DECISION OF THE QUEENSTOWN LAKES DISTRICT COUNCIL

Applicant:	Queenstown Lakes District Council
RM reference:	RM160315
Application:	Application under Section 88 of the Resource Management Act 1991 (RMA) for land use consent to install a meteorological utility with two masts, weather sensor, dish antenna, solar panels, and camera
Location:	Crown Range Summit car park, Crown Range Road, Cardrona
Legal Description:	Secs 5-8 18-25 Pt Secs 16-17 SO 432162
Zoning:	Rural General
Activity Status:	Discretionary
Notification Decision:	Volunteered Public Notification
Delegated Authority:	Jane Sinclair, Independent Commissioner
Final Decision:	GRANTED SUBJECT TO CONDITIONS
Date Decisions Issued:	11 April 2017

SECTION 42A REPORT

Proposal: Application under Section 88 of the Resource Management Act 1991 (RMA) for land use consent to install a meteorological utility with two masts, weather sensor, dish antenna, solar panels, and camera

Site and Location Plan

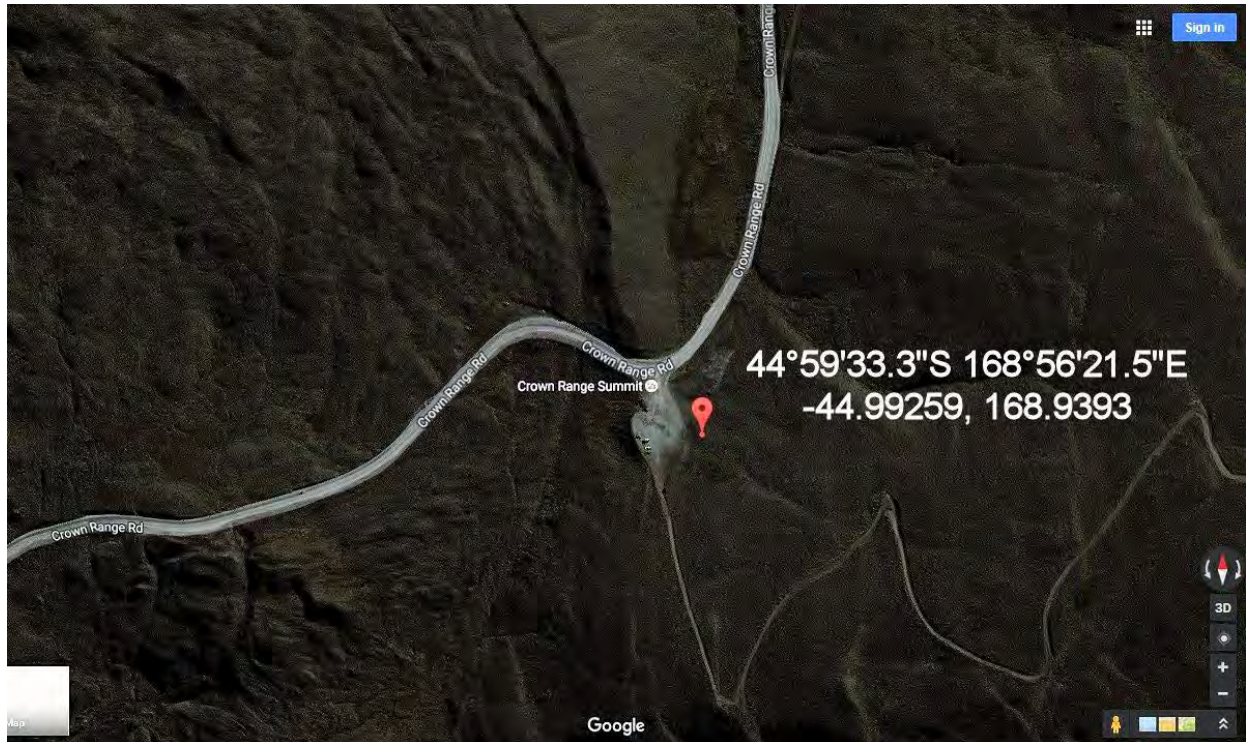
9. There is very limited ability to visually absorb the structure within the open landscape. I consider there would be a conflict with the natural landform and vegetation patterns as the landscape is open and stark in nature and the structure would be an obvious intrusion. Recessive dark grey colouring of all components including dish antennae, attached utility boxes, any signage, exposed wiring or ducting etc. and covering the concrete plinth with earth and replanting would assist in reducing prominence of the structure in longer and mid distance views where there is a backdrop of the slope behind. The skyline breach could be avoided by locating the structure to drop below the low ridge and road cutting as viewed from the north and I recommend that the structure location be adjusted slightly to achieve this.

- i. The site plan shall be amended to illustrate the location of the metrological structure in a position that will not breach the skyline as viewed from any location along the Cardrona Range Road.

- i. The site plan shall be amended to illustrate the location of the metrological structure in a position that will not breach the skyline as viewed from any location along the Cardrona Range Road.
